# Notice of Allowability

09/913,780

MOULIN, MICHEL

### **EXAMINER'S AMENDMENT**

Fig. 5

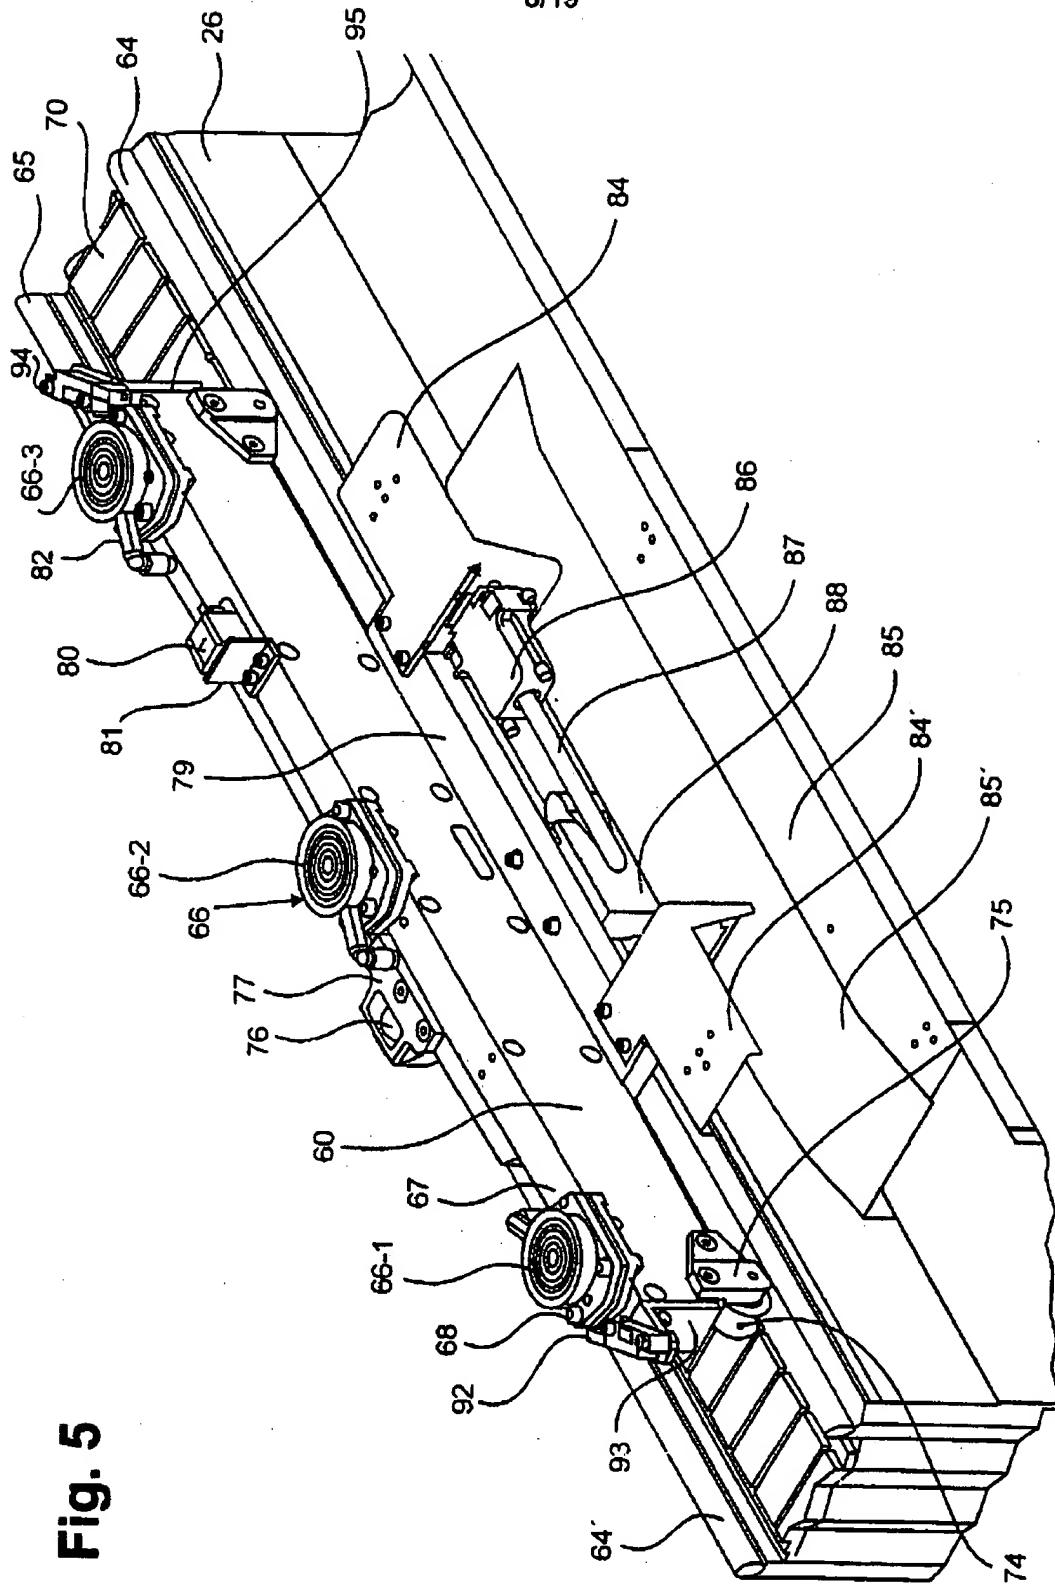
Authorization for this examiner's amendment was given in a telephone interview with David Novais, no. 33,324, on 15 October 2007. The examiner suggested removing Fig. 5A from the drawings, as Fig. 5A is not described in the specification. The examiner requested that Applicant a substitute drawing sheet to this effect.

In the Drawings, old sheet 6/19 (containing Figs. 5 and 5A) has been replaced with the attached replacement sheet (containing only Fig. 5) received 17 October 2007.
